**Subject:** Advanced Response to U.S. EPR Design Certification Application RAI No. 525 (6194, 6154), FSAR Ch. 9, Questions 09.01.04-22, -24, -25, -26 & -30  
**Sent Date:** 3/15/2013 1:47:05 PM  
**Received Date:** 3/15/2013 1:47:29 PM  
**From:** NOXON David (AREVA)

**Request for Additional Information No. 525(6194, 6154)**

**U.S. EPR Standard Design Certification**

**SRP Section: 09.01.04 - Light Load Handling System (Related to Refueling)**

Figure 09.01.04-30-1  
Spent Fuel Cask Transfer Machine- Main Structural Assemblies

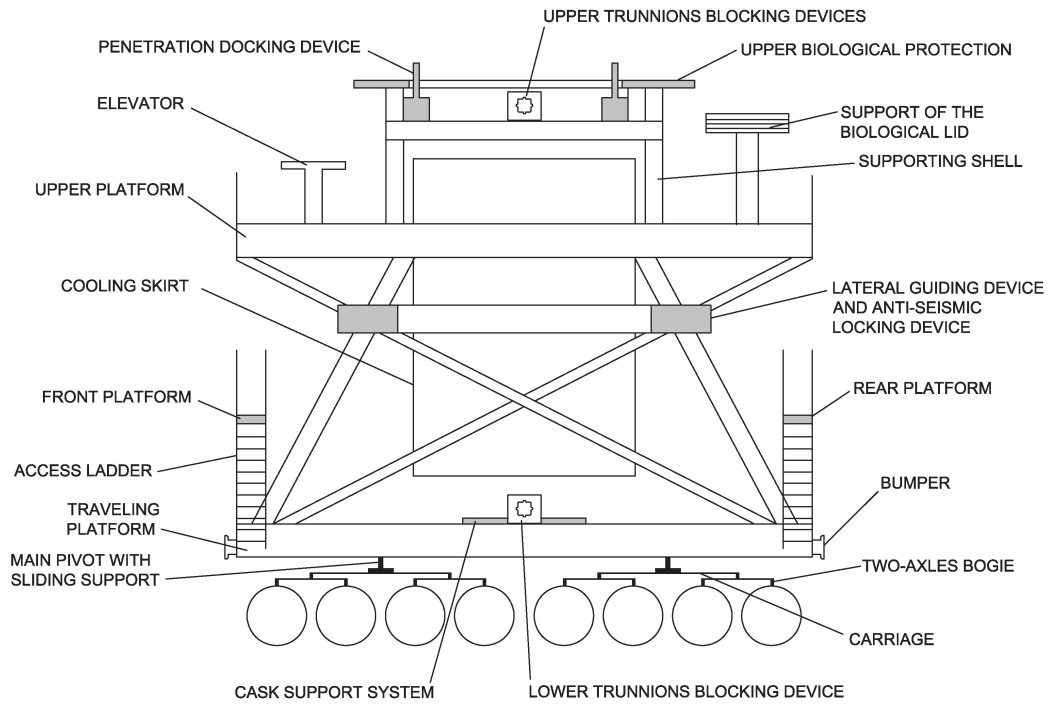
Section 9.1.4.2 of US EPR FSAR Revision 4 Interim (August 31, 2011, Response to RAI 385) described that the SFCTM is designed in accordance with the applicable portions of ASME NOG-1-2004. Since ASME NOG-1-2004 is specific to overhead and gantry cranes while the SFCTM is described as a trolley in the FSAR, the applicant is requested to provide the following:

As shown in Figure 09.01.04-30-1 □ Spent Fuel Cask Transfer Machine-Main Structural Assemblies, and as described below, the SFCTM has three main structural assemblies:

Figure 09.01.04-30 will be added as a new figure to U.S EPR FSAR Tier 2, Section 9.1.4.2.2 as U.S. EPR FSAR Tier 2, Figure 9.1.4-13 □ Spent Fuel Cask Transfer Machine-Main Structural Assemblies.
